Re: Permit Modification – Attachment 5 and Attachment 14
McCommas Bluff Landfill, TCEQ Permit No. 62
Dallas County, Texas

PERMIT MODIFICATION

**ATTACHMENT 5
GROUNDWATER CHARACTERIZATION REPORT AND
GROUNDWATER MONITORING PLAN**

LANDFILL GAS MANAGEMENT PLAN

MCCOMMAS BLUFF LANDFILL
APPENDIX 5B
GROUNDWATER MONITORING SYSTEM

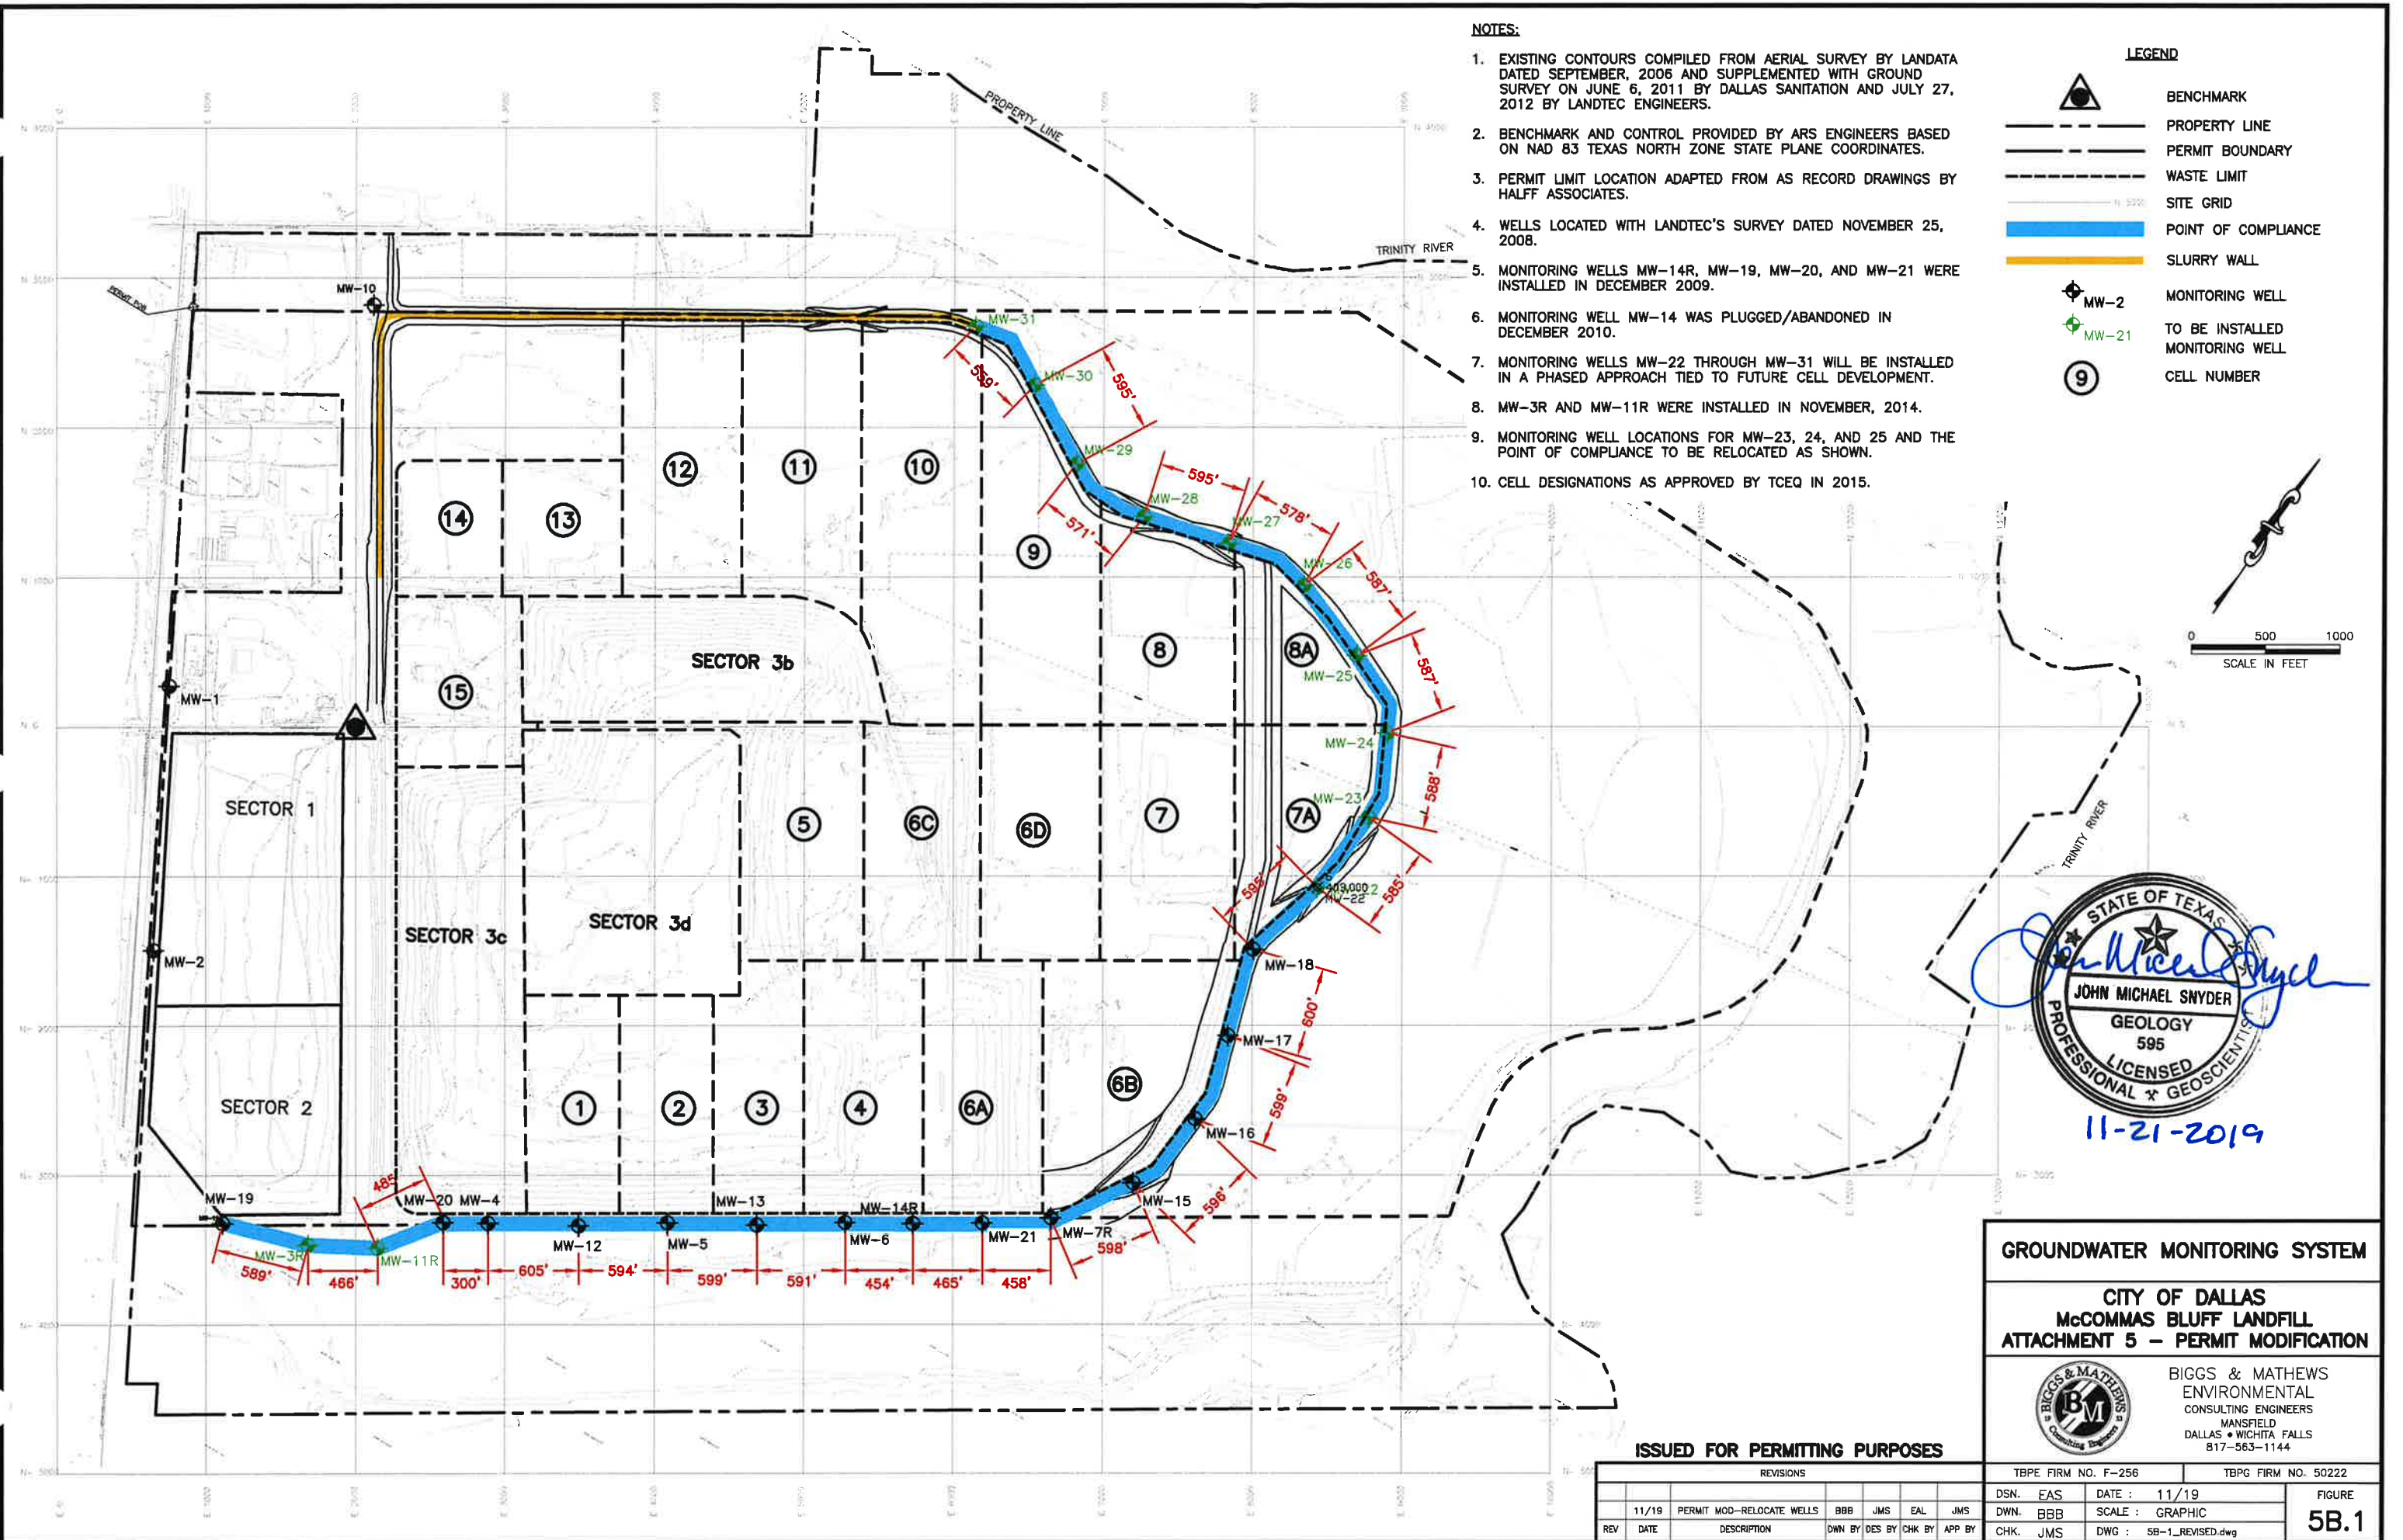
First, this permit modification addresses changes to **Attachment 5 – Groundwater Characterization Report and Groundwater Monitoring Plan**. Specifically, proposed monitoring wells 23, 24, and 25 are being relocated and accordingly the point of compliance is being relocated. This change is necessitated by a previous permit modification approved by TCEQ in 2015 that revised the waste footprint. This modification relocates the referenced monitoring wells and point of compliance to the east of the revised footprint for Sector 7A. The new monitoring well locations maintain well spacing that is less than 600 feet between wells. This modification also incorporates the installation data for previously installed monitoring wells 3R and 11R which were installed in 2014.
